HOWARD COUNTY HISTORIC PRESERVATION COMMISSION  
*ELlicott City Historic District ■ LAWYERS HILL Historic District*  
3430 Court House Drive ■ Ellicott City, Maryland 21043

## April Minutes

Thursday, April 5, 2018; 7:00 p.m.

Figure 2 - Proposed location of new door

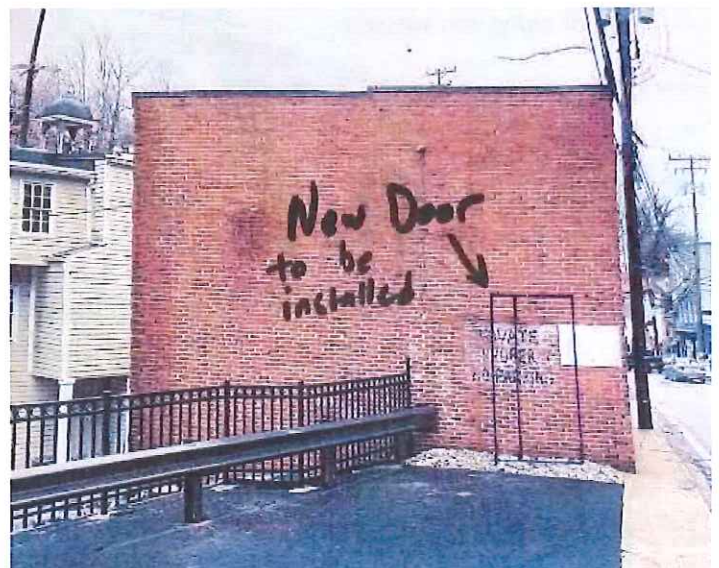
**Staff Comments:** Chapter 6.G generally recommends against, “changing the size of door openings; blocking or filling door openings, transoms or sidelights” and “cutting a new entrance into a primary façade or in any location where it destroys historic features important to the buildings character.” The proposed location for the new door does not contain any unique historic features whose loss would degrade the architectural integrity of the building more so than the existing location of the service door. The rear location is not a primary façade. The relocation of the service door from the Old Columbia Pike side of the building to the rear of the building results in a safer access point than the existing location provides.

The proposed door is a flush metal door, which will replace a flush wood door. Chapter 6.H recommends against, “using flush doors without trim or panels...on historic buildings or on non-historic buildings in a highly visible location.” However, given the

ornate and unique nature of the paneled doors on the front of the building, the most appropriate design for a rear service door is the proposed flush door. A flush door will blend into the rear façade, rather than standing out as potential entrance door, which could happen if the door was more decorative.

The color of the mortar was not referenced in the application, but the mortar color should be matched to the existing, in order to for the brick fill to blend seamlessly into the side of the building.

**Staff Comments:** Staff recommends Approval of as amended. Staff recommends the music posters be removed from the Old Columbia Pike side of the building and that an application for Certificate of Approval be submitted for the main sign.

Figure 7 – Location of preserved land in Lawyers Hill

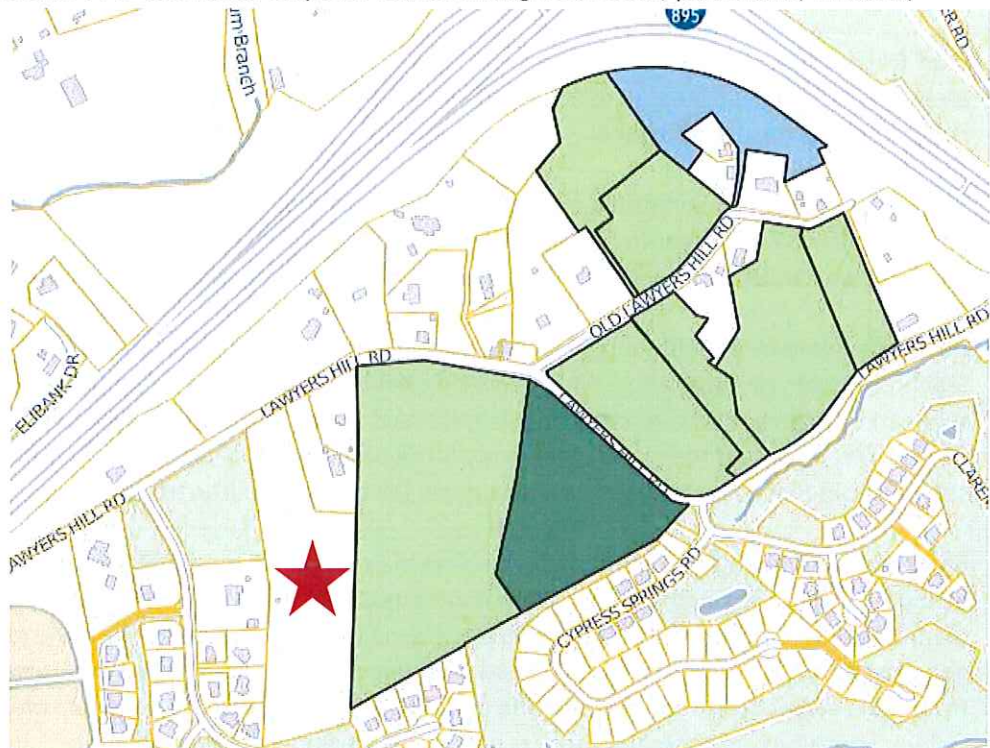
Aside from architecture, the landscaping in Lawyers Hill is also important. The nomination form explains, “historically, there has been a great emphasis on landscaping in Lawyers Hill...A wide diversity of forest trees continue to flourish on the hill, among them ash, beech, chestnut, sugar maple, oak, hickory, cedar, blue spruce, pine, lindens, dogwoods and hollies. Numerous ornamental trees and shrubs also survive on Lawyers Hill, some over one hundred years old, including boxwoods, paulownia, wisteria, rhododendron and roses. Mature fruit trees planted in the yards of many houses include apples, pears, peaches and cherry. The landscape is a carefully guarded legacy.” This legacy has been further guarded through voluntary land easements that many property owners have added over the years. The easements in Lawyers Hill include Rockburn Land Trust easements, Conservation easements, Maryland Environmental Trust

easements and Maryland Historical Trust easements (easements shown in green and blue below, subject property shown with a red star).

**Staff Recommendation:** Staff recommends any site plan that is developed takes into account the architectural and historical significance of Lawyers Hill and respects and complements these characteristics described above.

**Figure 11 - Sketch of front façade of proposed house**

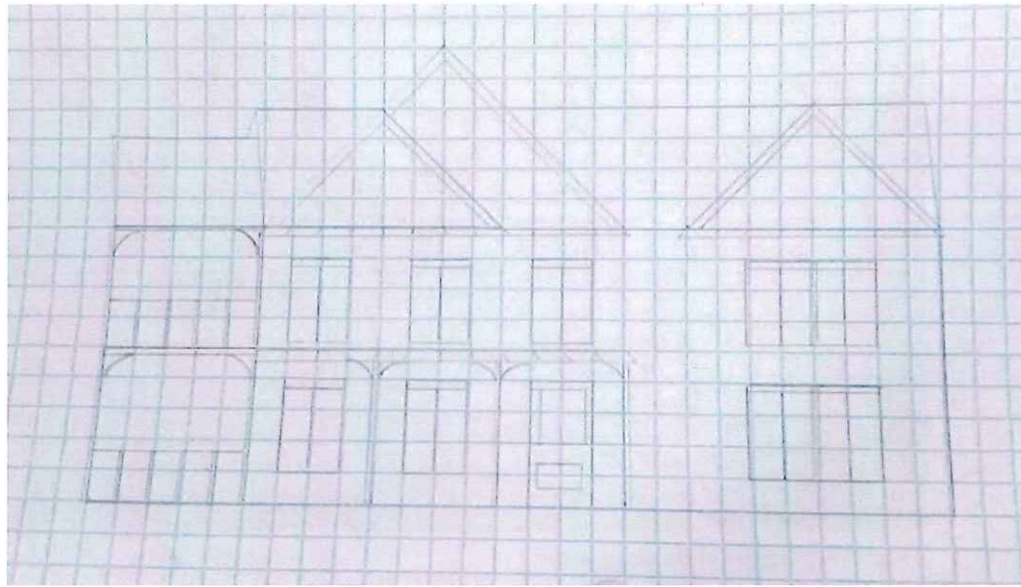
The Applicant has provided a sketch of the front façade of the house, which will require a future Certificate of Approval, along with all other building elevations and materials. Chapter 8 recommends, “design new buildings to be compatible with neighboring buildings in bulk, ratio of height to width and the arrangement of door and window openings.” Chapter 8.B also recommends “use a building form or shape compatible with historic buildings that are part of the same streetscape. This is particularly important for new buildings on infill lots where existing buildings along the street are similar in form.” The proposed building is significantly wider, at 54 feet (including the side porch) than the neighboring historic structures, which range approximately from 30 feet to 39 feet in width. Most of the houses on Fels Lane are 3 to 4 bays wide and the proposed house would be 5 bays wide with a void between the right and center sections that could almost count as an additional bay. There is only one house on Fels Lane with a side porch (which is listed on the Historic Sites Inventory as HO-1131 and is the most historic house on the street.) This house was constructed by Ezra Fell, for whom the street is named, and dates approximately to 1820-1825. The other houses along Fels Lane do not have side porches and only have front porches. The building form and shape is much wider than the historic houses on the street and should be shortened and the side porch removed in order to comply with the Guidelines.

Chapter 8.B of the Guidelines recommends, “use a roof shape and slope that echoes the roof forms of neighboring historic structures” and “use a building form or shape compatible with historic buildings that are part of the same streetscape. This is particularly important for new buildings on infill lots where existing buildings along the street are similar in form.” The roofline does not echo the forms of neighboring historic structures due to the number of front gables, and therefore should be simplified to one front gable. The double set of gables can be found in Craftsman architecture and some high style Queen Anne buildings, as a bay projecting from the building, but is more commonly seen in this area in new construction. This feature is not compatible with the historic buildings on Fels Lane.

The area of the house on the right, referred to above as the second bay with paired windows and one gable, reads as an addition to the house and appears detached from the rest of the house. There is no local historic precedent for the two gable roofs to be placed side by side. Detailed construction drawings are required for the future Certificate of Approval. In particular, there should be a detail drawing of the paired windows to understand what the trim will look like and what the window sash arrangement will be. Based on previous meetings where the Commission has reviewed similar applications, detail drawings should also be provided that show what the porch railings, posts and roof will look like and how they will connect.

Mr. Reich said the double overlapping gable is a 1980s/90s suburban design feature. The cross gable on the front reflects old Howard County farmhouses. Mr. Reich recommended creating a larger and wider front porch that would better fit into the historical context. Mr. Reich said the Commission need more architectural details such as quarter inch scaled drawings showing the trim, sizes, colors, windows and other design details. Mr. Reich agreed with Staff's recommendation to make the design reflective of the neighborhood then return to the Commission with revised drawings.

Mr. Reich said there is a 10-foot drop across the front of the house that is not reflected in the elevation. Mr. Reich asked about the design of the rear and side with the existing topography, as the submitted elevation shows it all level. He recommended the Applicant revise the drawing then return to the Commission to explain how the revisions fits into the historical context.

**Staff Recommendation:** Staff recommends the footprint of the house be reduced in width and the roofline reconfigured, to better comply with the Guidelines.

Figure 13 - Proposed brick

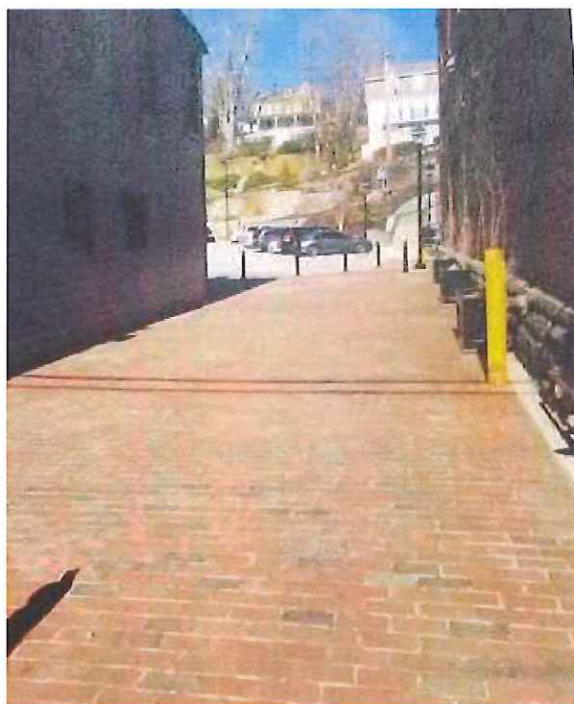
**Staff Comments:** The application complies with Chapter 9.D, "construct new site features using materials compatible with setting and with nearby historic structures, particularly for features visible from a public way," and "construct new terraces or patios visible from a public way from brick, stone or concrete pavers design to look like indigenous stone." The brick will complement the historic building, which features a stone exterior wall and will complement the adjacent stone stream walls. The proposed brick also complies with the Guidelines and will improve consistency in design throughout the historic district.

Figure 14 - Proposed site plan

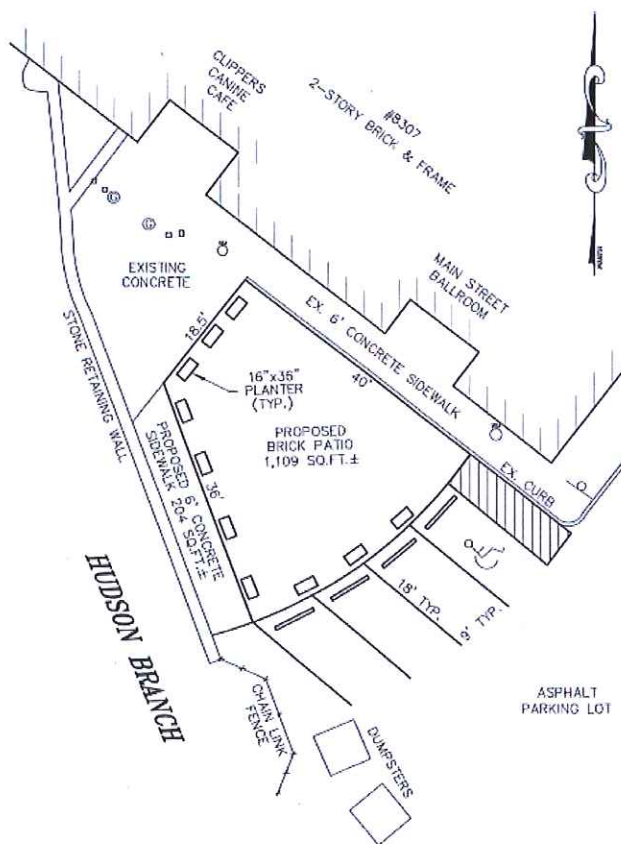
The proposed brick will match that used by the County in the plaza and alley in Parking Lot E. The brick patio will be installed flush with the level of the adjoining asphalt to prevent a trip hazard. The brick pavers will be commercial grade. The patio will drain slightly downhill toward the parking spaces, as it currently does. All curbs will be a standard height. The walkway to Canine Clippers Café will be a ramp at the end so that it is accessible.

The Applicant proposes to place 10 planters on the patio (the style is shown in Figure 15) forming a barrier to the surrounding area. The Applicant may also want to consider a removable railing system to contain the space and to prevent spill-over. A removable system would be preferred over a permanent railing so that there is flexibility in the space as tenants and building use changes over time.

**Staff Recommendation:** Staff recommends Approval of the patio design as submitted and recommends the Applicant also identify a removable railing system.

Figure 17 - Location of emergency egress door

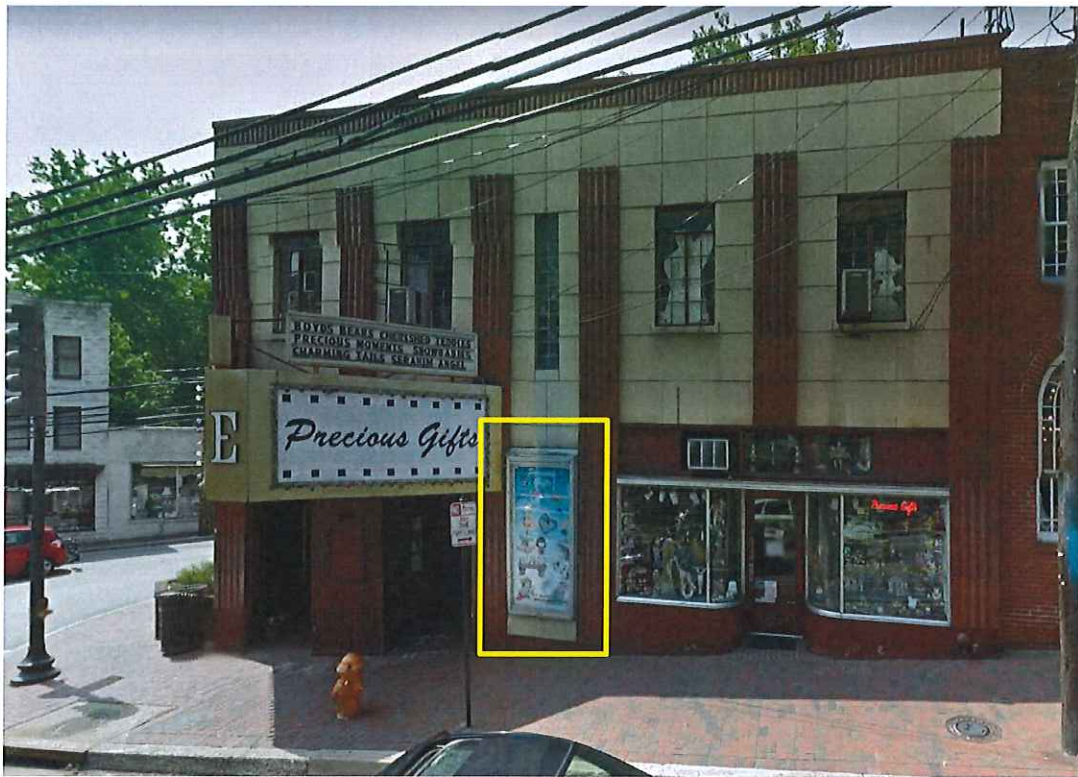
**Staff Comments:** The proposal generally complies with Chapter 6.K recommendations for storefronts, “preserve the form and details of existing historic storefronts.” The goal of the project is to install a door for emergency egress, but keep the form and details from the existing façade so that a door does not appear visible from the exterior. The Applicant presents three scenarios for discussion purposes. However, the differences between the scenarios are not clear and further clarification is needed. In Scenario 2 a course of ceramic tile below the movie poster enclosure will need to be removed for the installation of the door, and the ceramic course would be installed in the header space above the door. This would result in the movie poster enclosure frame lining up with the storefront windows. Chapter 6.K recommends against, “using a new storefront design that is not based on the building’s historic façade.” In all photos reviewed by staff, the movie poster enclosure frame is always higher than the storefront windows.

**Testimony:** Mr. Shad swore in Trae Reuwer. Mr. Shad asked if there were any additions or corrections to the Staff comments or application. Mr. Reuwer said the egress door is required by DILP. He explained there is about a 6-inch elevation difference between the sidewalk and the interior stairs. Mr. Reuwer said one option is to make the tile part of the door and the movie poster board case would become the door. Mr. Reuwer said the second option would be to recreate the movie poster board extending down to the ground, to be the whole door length, and then remove the tiles below the existing poster case. The third option is to remove the tile, extend the length of the door at street level. Mr. Reuwer said the door will only be used in emergencies, such as in a fire. Ms. Tennor asked if the remodeled door would still have the same look as now. Mr. Reuwer said yes, for the most part.

**Staff Recommendation:** Staff finds the plan is a creative solution to the egress problem and recommends using whichever scenario alters the historic façade the least.
